To: Honorable Mayor Patrick Collins and Members of the City Council
From: Brandon T. Gilchrist, Planner I
Subject: PUDC-25-3 / Harmony Valley 5th Filing / Final Plat
Date: March 10, 2025

CITY OF CHEYENNE PLANNING COMMISSION
March 3, 2025
STAFF REPORT

FILE: PUDC-25-3: Harmony Valley, 5th Filing (Expedited Review)

REQUEST: A plat creating 112 lots for residential development

FINAL PLAT

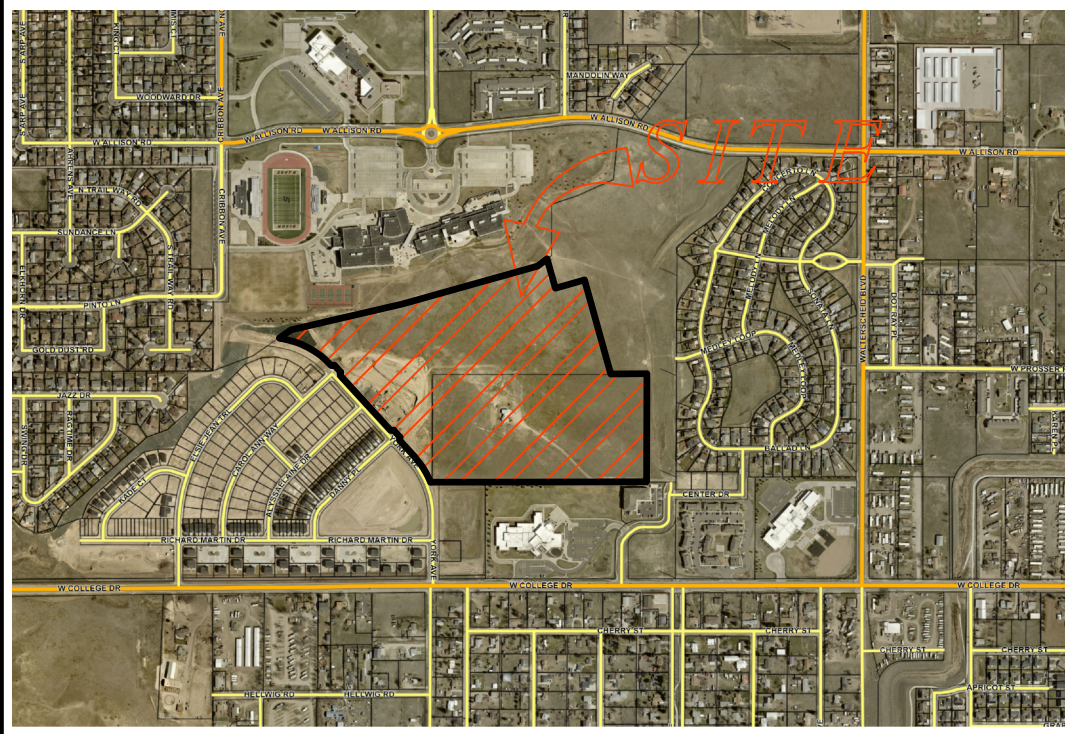
This plat seems well-equipped to deliver all necessary enhancements and utilities. However, the proposed BOPU facilities within the plat boundary will require easements wherever the right-of-way for the mains is insufficient.

1. The following exception is to be granted:
 - a. Exception to UDC 4.3.3.c, regarding minimum block size and connectivity
2. Prior to approval of the final plat the following shall be required:
 - a. Provide appropriate easements for the proposed BOPU facilities on the face of the plat, including the applicable note.
